**UNITED STATES
NUCLEAR REGULATORY COMMISSION
WASHINGTON, D.C. 20555-0001**

U.S. NUCLEAR REGULATORY COMMISSION
EVALUATION BY THE OFFICE OF NUCLEAR MATERIAL SAFETY AND SAFEGUARDS
OF THE CLASS 1 FINAL STATUS SURVEY REPORTS, LICENSE TERMINATION
ACTIVITIES AT THE REACTOR SITE, AND PARTIAL SITE RELEASE
FOR POSSESSION ONLY LICENSE NO. DPR-45
LACROSSESOLUTIONS, LLC
LA CROSSE BOILING WATER REACTOR
DOCKET NO. 50-409

Figure 30. Turbine Building Survey Boundaries for ORISE and LaCrosseSolutions

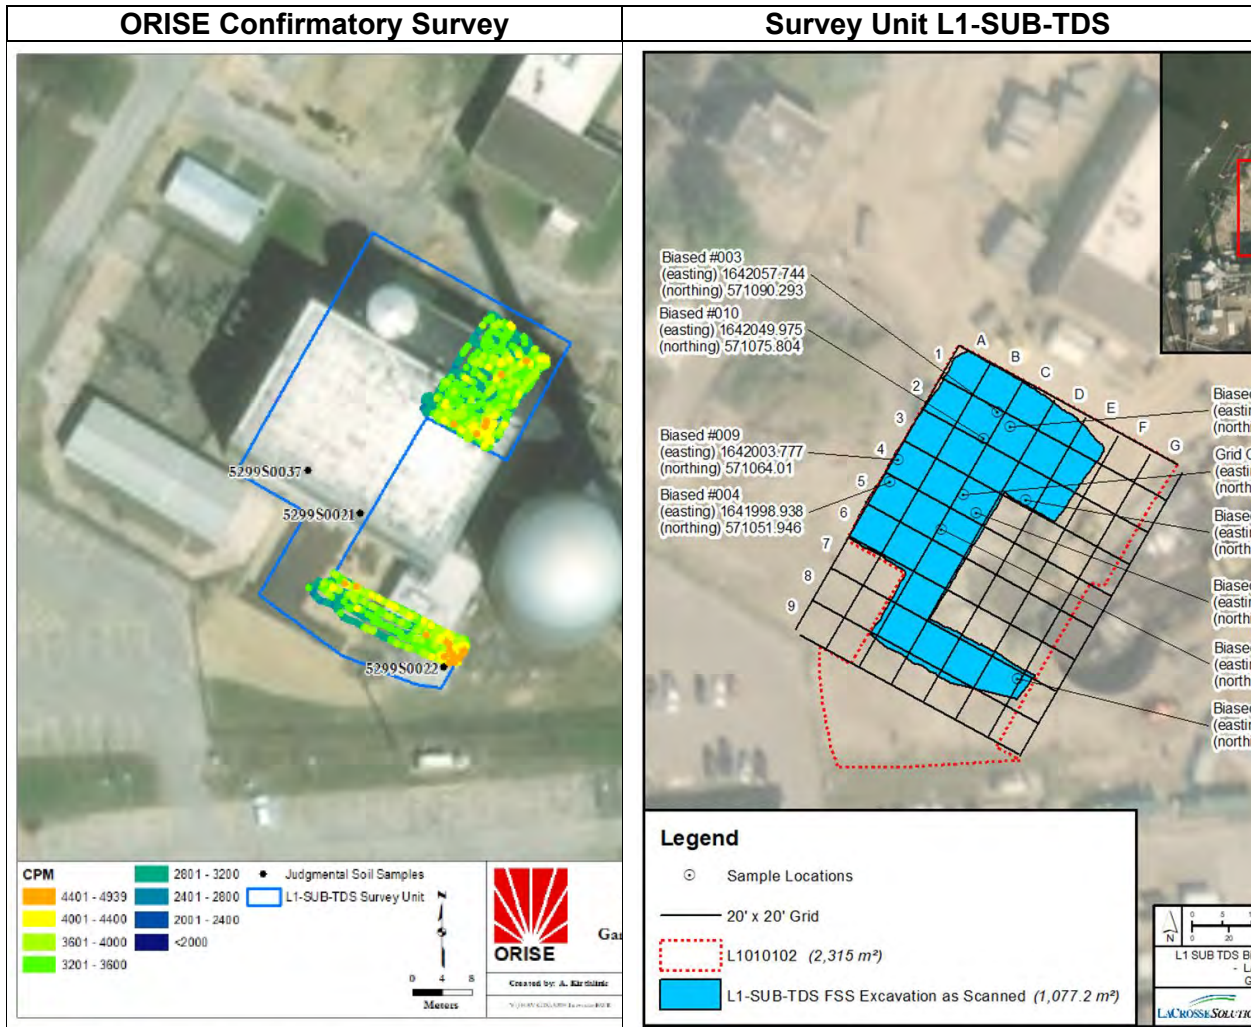
The ORISE confirmatory survey noted that the physical boundary established by LACBWR for the turbine building excavation did not match the planned survey boundary established in the geographic information system (GIS) mapping files, as indicated by the difference between the ORISE and licensee survey area demarcations shown in Figure 30. As part of the supplemental information provided in support of the clarification teleconferences to discuss the LACBWR FSSR ([ML22269A392](#)), the licensee confirmed that the portion of the LACBWR turbine building excavation that was not scanned by ORISE during their confirmatory survey activities was scanned by LaCrosseSolutions survey technicians during FSS of Survey Unit L1-SUB-TDS.
